SUBJECT: PLANS AND PROPOSAL ADDENDUMS
PROJECT: STP 2023 (675)MM CONTROL: 1433-02-044
COUNTY: COMAL
LETTING: 05/04/2023
REFERENCE NO: 0419

PROPOSAL ADDENDUMS

DESCRIPTION OF ABOVE CHANGES
(INCLUDING PLANS SHEET CHANGES)

NOTE:
SEE EXISTING UTILITY LAYOUT SHEETS
FOR THE EXISTING UTILITY LEGEND

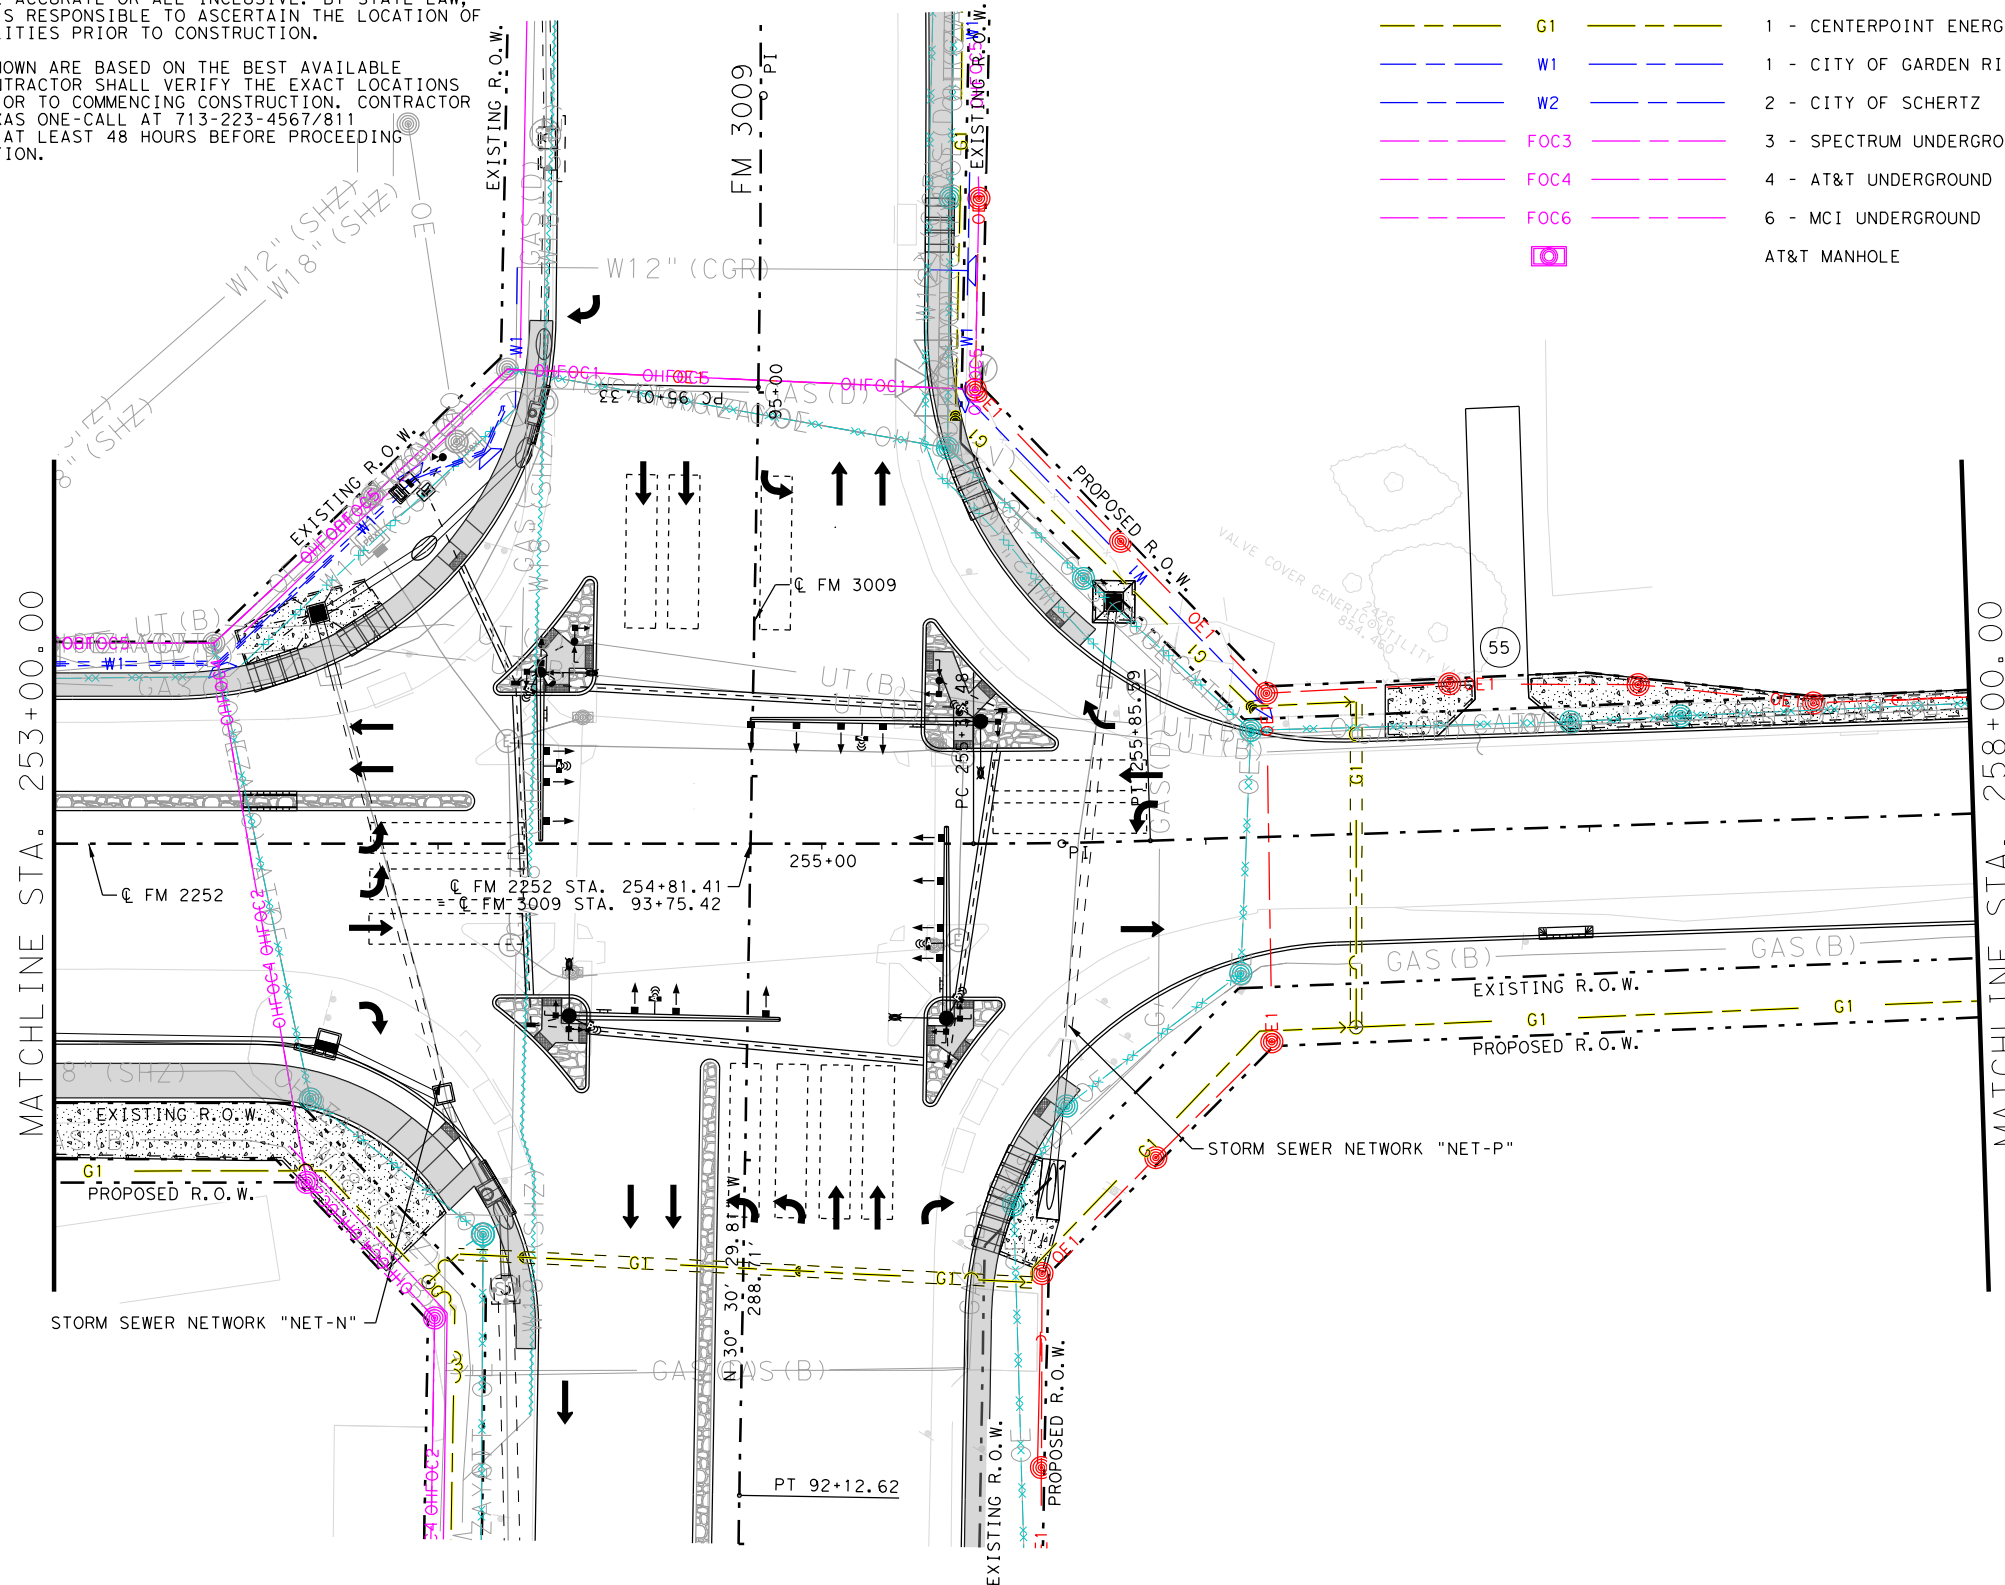
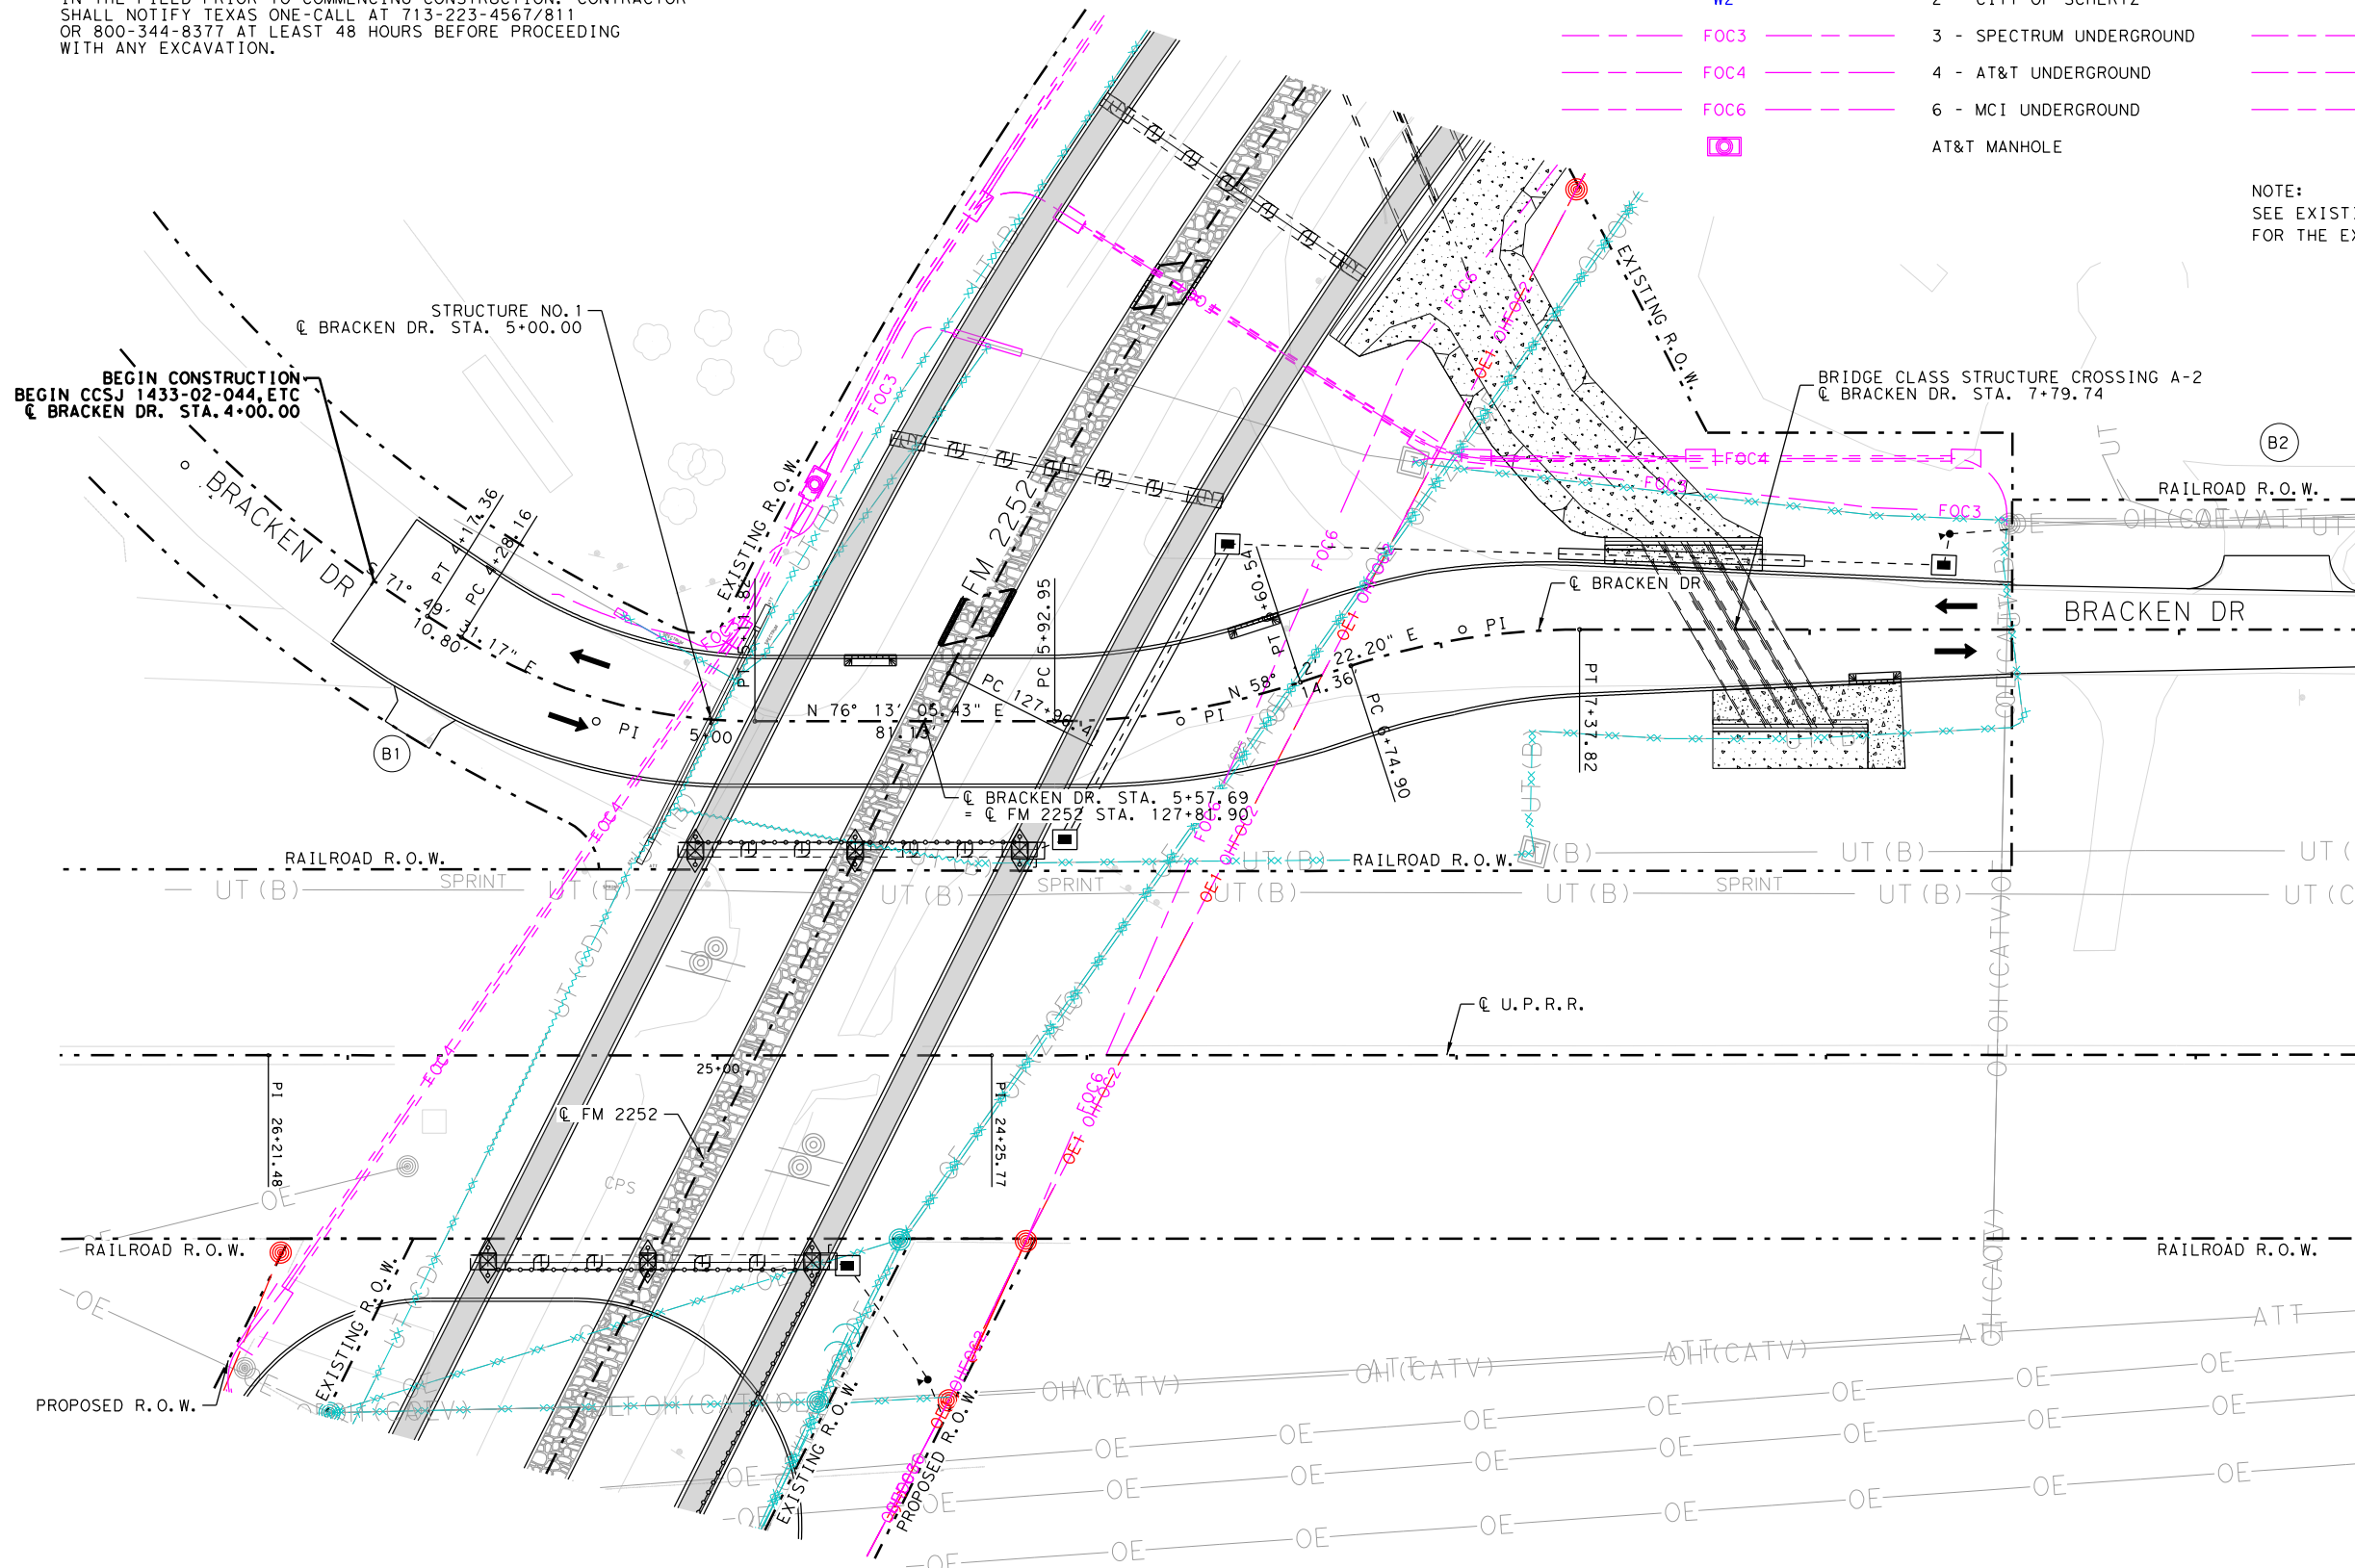
SHEETS 1330-1365: UPDATED UTILITY PLANS SHEETS LAYOUTS WITH CURRENT GAS
